**METROPOLITAN GOVERNMENT OF NASHVILLE AND DAVIDSON COUNTY**

**STAFF RECOMMENDATION**  
**1511 Ferguson Avenue**  
**February 18, 2015**

**Application:** Partial demolition; New construction—addition with ridge raise  
**District:** Belmont-Hillsboro Neighborhood Conservation Zoning Overlay  
**Council District:** 18  
**Map and Parcel Number:** 11708014000  
**Applicant:** Brian Layton  
**Project Lead:** Melissa Baldock, melissa.baldock@nashville.gov

<p><b>Description of Project:</b> Application is to demolish an existing rear addition, reconfigure an existing side porch, and construct a rear addition and ridge raise.</p> <p><b>Recommendation Summary:</b> Staff recommends approval of the project with the following conditions:</p> <ol style="list-style-type: none"> <li>1. The applicant retain and restore the historic wood siding if it is revealed when the vinyl siding is removed, or the applicant retain the historic windows;</li> <li>2. Staff approve the final details, dimensions and materials of windows and doors prior to purchase and installation;</li> <li>3. The HVAC shall be located behind the house or on either side, beyond the mid-point of the house; and</li> <li>4. Staff

Figure 1 (left) shows the current conditions of 1511 Ferguson and Figure 2 shows the 1951 Sanborn Map.

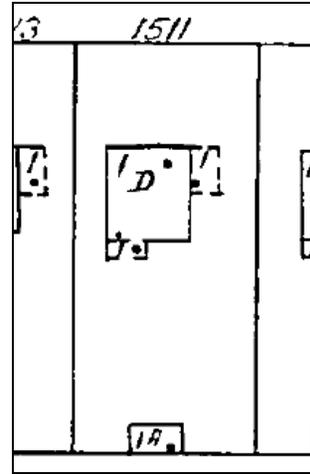
1511 Ferguson is a c. 1925 cottage style structure that contributes to the historic character of the Belmont-Hillsboro Neighborhood Conservation Zoning Overlay (Figure 1). The side porch appears to be a historic feature, as it appears on the 1951 Sanborn Map (Figure 2). However, a c. 1968 photograph of the house shows that the side porch's current roof and columns are not original (Figure 3).

FIRST FLOOR DEMO PLAN

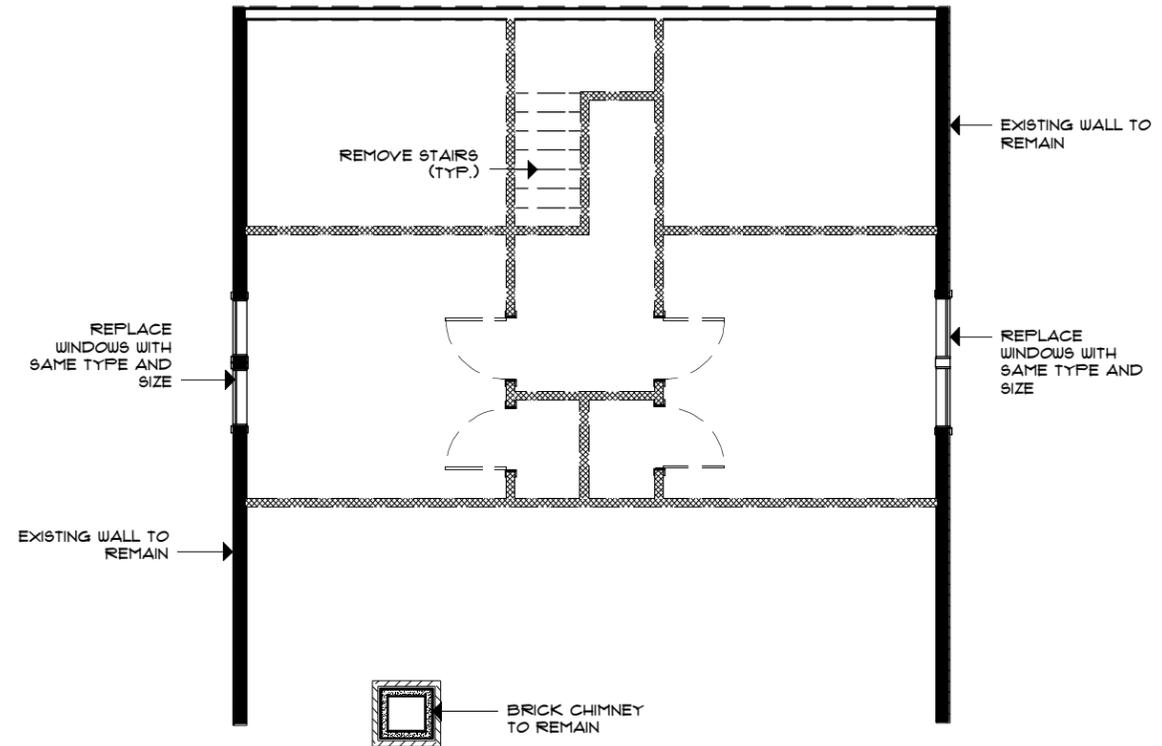
Demolition: The applicant is proposing to demolish a non-historic rear addition (Figures 4 & 5). The addition does not appear on the 1951 Sanborn map and does not contribute to the historic character of the house. Staff therefore finds that its removal meets the design guidelines.

**PRELIMINARY SITE PLAN**  
SCALE: 3/32" = 1'-0"

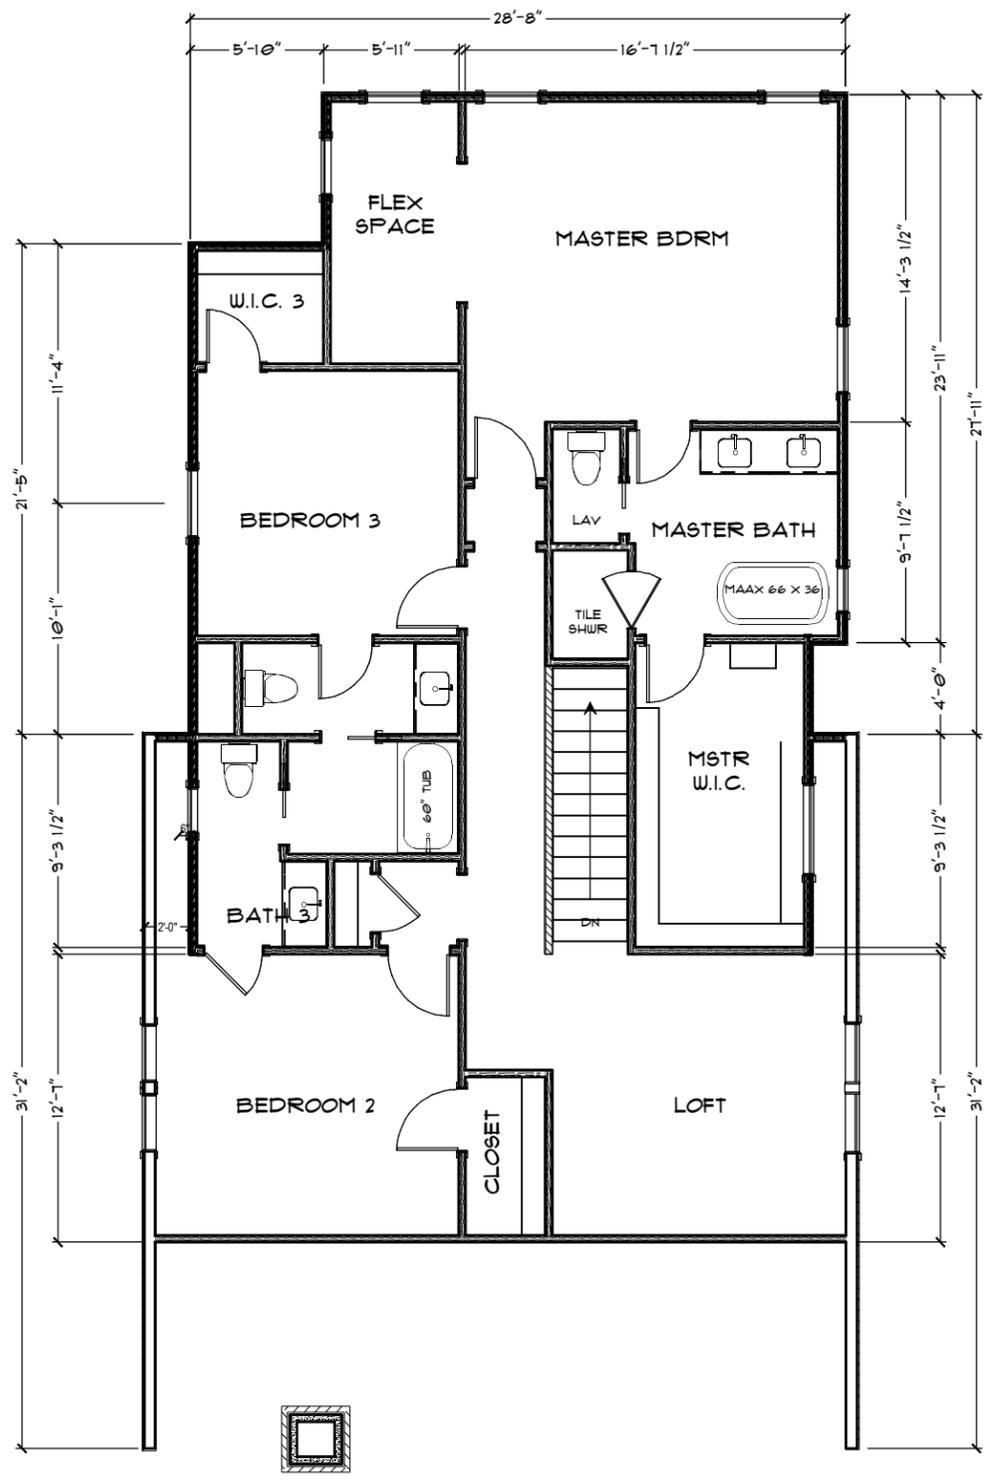
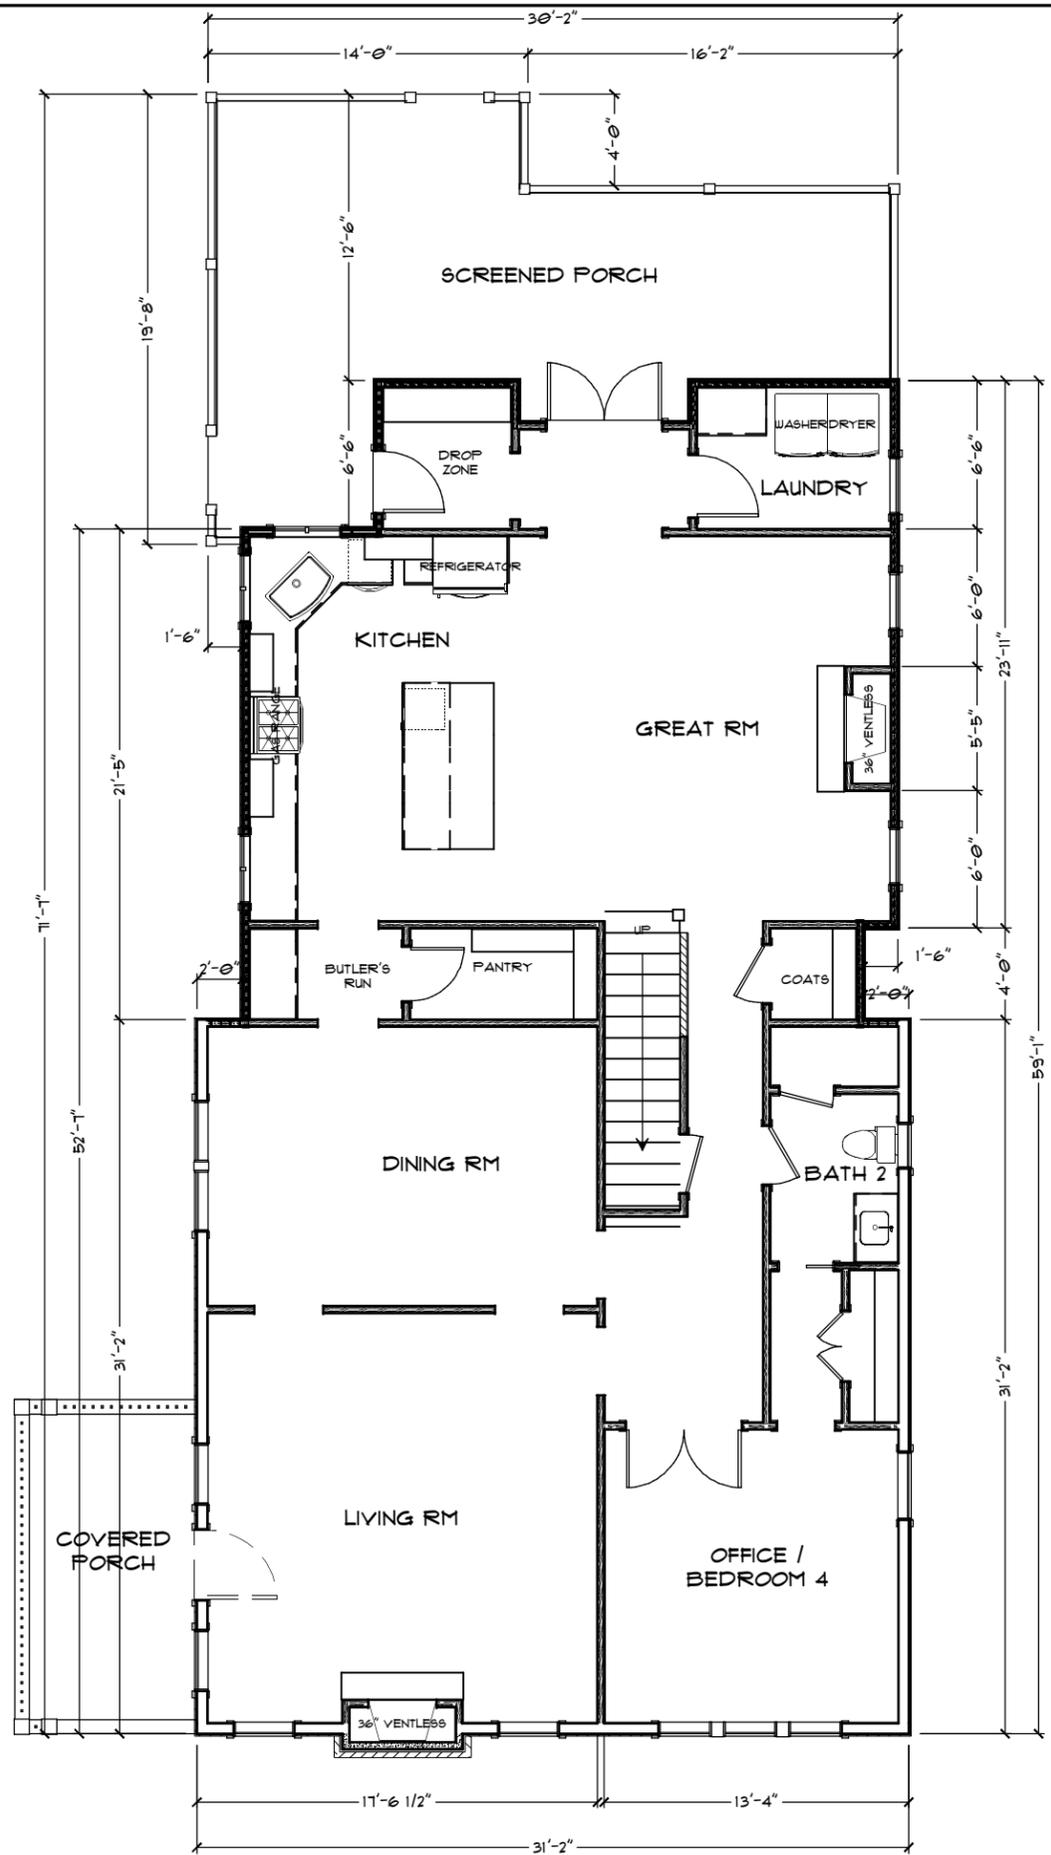
Setback & Rhythm of Spacing: The proposed addition meets all base zoning setbacks. It will be over twelve feet (12') from the right side property line and over nineteen feet (19') from the left side property line. It will be over forty feet (40') from the rear property line. Staff therefore finds that the addition meets sections II.B.1.c. and II.B.2. of the design guidelines.

Appurtenances & Utilities: The applicant will be replacing the existing driveway on the left side of the property, and will be adding new sidewalks from the driveway to the side porch steps. The location of the HVAC and other utilities was not noted. Staff asks that the HVAC be located on the rear façade, or on a side façade beyond the midpoint of the house.

1. The applicant retain and restore the historic wood siding if it is revealed when the vinyl siding is removed, or the applicant retain the historic windows;
2. Staff approve the final details, dimensions and materials of windows and doors prior to purchase and installation;
3. The HVAC shall be located behind the house or on either side, beyond the midpoint of the house; and
4. Staff approve the roof color, dimensions and texture.

EXISTING LEFT SIDE ELEVATION

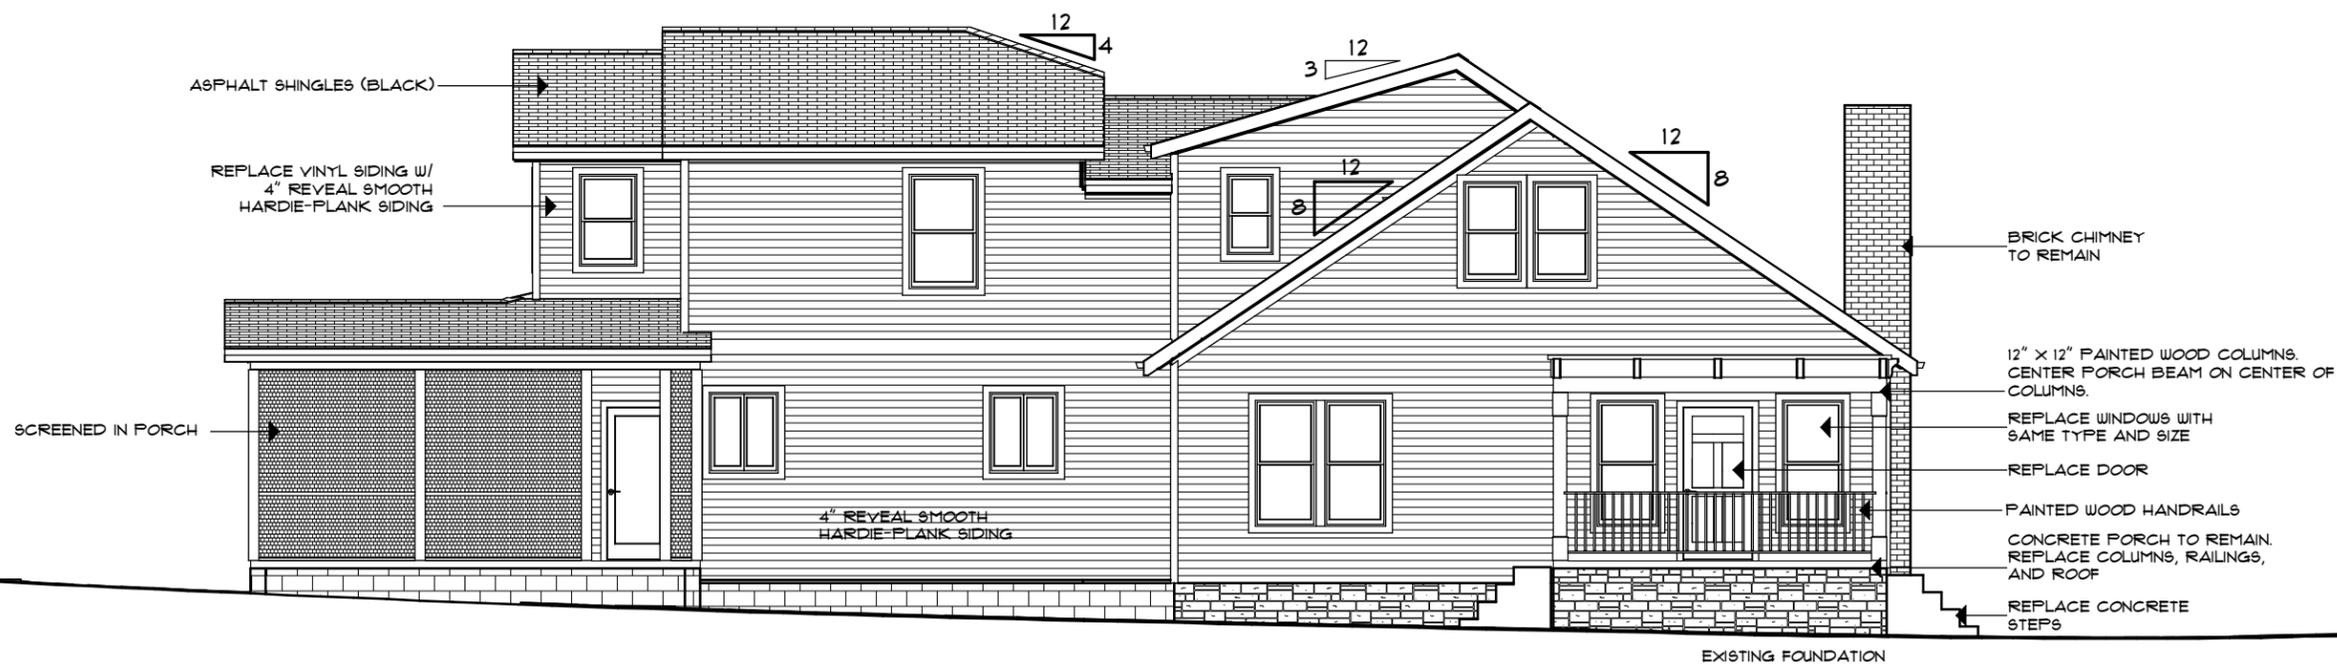
The applicant is proposing to alter the non-historic conditions of the highly visible side porch. Because these changes are based on photographic evidence and will bring the porch closer to its historic condition, staff finds them to be appropriate. Staff finds that the addition meets sections II.B.2.a and e. of the design guidelines.

Roof form: The applicant plans a two foot (2') ridge raise that is appropriately set in two feet (2') from the side walls. The applicant also plans to replace the existing metal porch roof and columns with a new design that matches historic photographic evidence. The new porch roof will be flat. The rear addition's roof form will be clipped at the front and gabled at the rear and meets the design guidelines. Staff finds that the project's roof forms meet sections II.B.1.e. and II.B.2. of the design guidelines.

Orientation: The alterations to historic house will not affect the house's orientation. Its primary entrance will remain on the left elevation, behind the side porch. Vehicular access to the site will be via an existing driveway on the left side of the site, and via the alley. Staff finds that the project's orientation meets sections II.B.1.f. and II.B.2. of the design guidelines.

EXISTING RIGHT SIDE ELEVATION

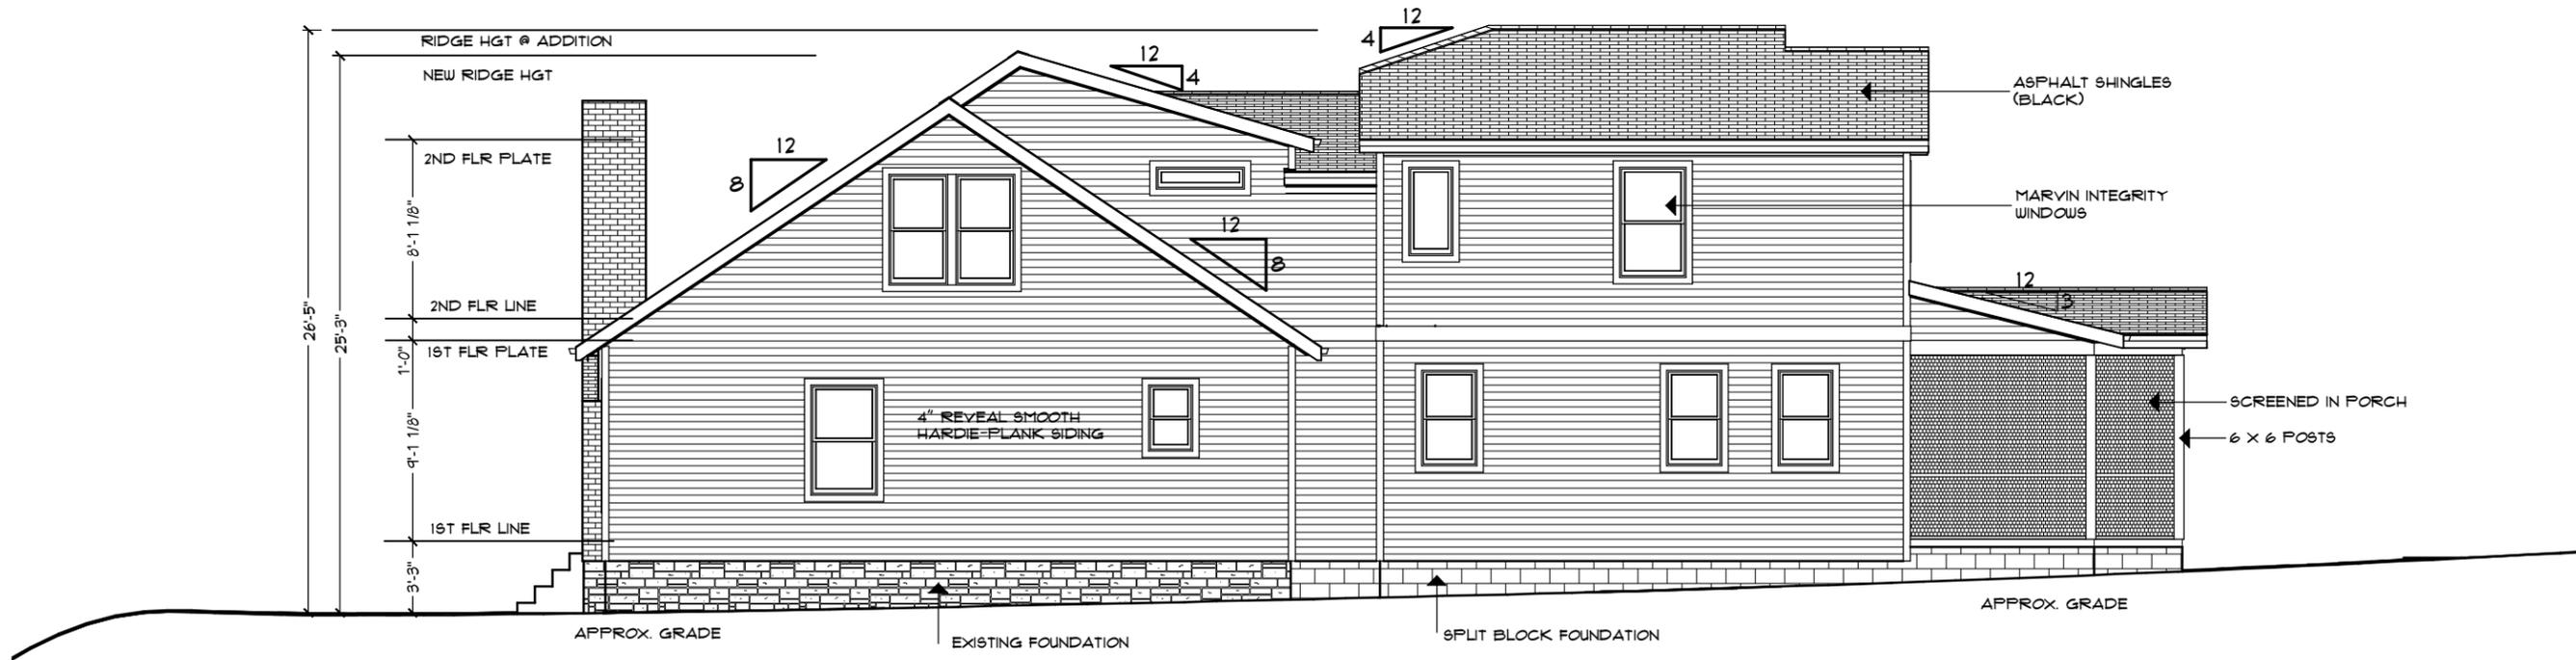
The applicant is proposing to relocate one window opening on the right elevation and alter the size of a window opening on this same façade, and this is also considered partial demolition. The relocated window opening will be situated closer to the front of the house than the existing, and will be at least twice as tall as it is wide. Staff finds it to be appropriate since it is not on the front façade and most of the remaining window openings on the house will be unchanged. The window opening that is to be altered is located towards the back of the right façade, where it will not be highly visible. Staff therefore finds it to be appropriate.

Height & Scale: The proposed addition will be taller than the historic house, but it will not be wider. The addition will step in two feet (2') from each of the back corners of the house. On the right side, after a depth of about four feet (4'), the addition steps back out eighteen inches (18") so that it is inset six inches (6") from the historic house's side wall. On the left side, the bulk of the addition remains inset at two feet (2'), except a screened porch at the rear will step back out eighteen inches (18") and will be just six inches (6") inset from the house's side wall.
